Job	Truss	Truss Type	Qty	Ply	LOT 28 PROVIDENCE CREEK 29 COTTONSEED LANE FUQUAY-VARINA,
23-7721-R01	R02RP1	Piggyback Base	3	1	Job Reference (optional)

Atlantic Building Components, Moncks Corner, South Carolina

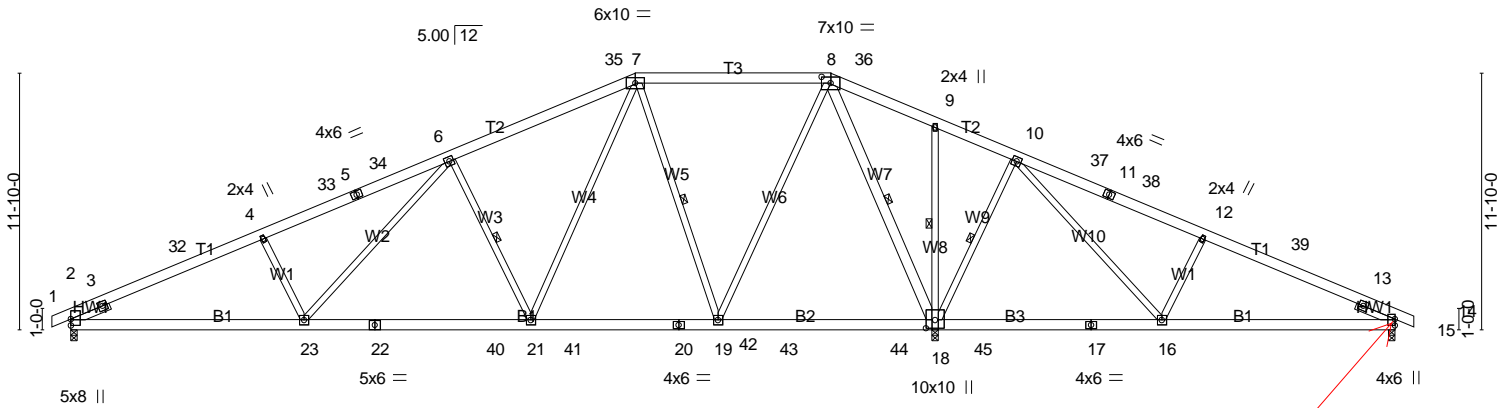
Toe-nail split. See MII-REP22 attached
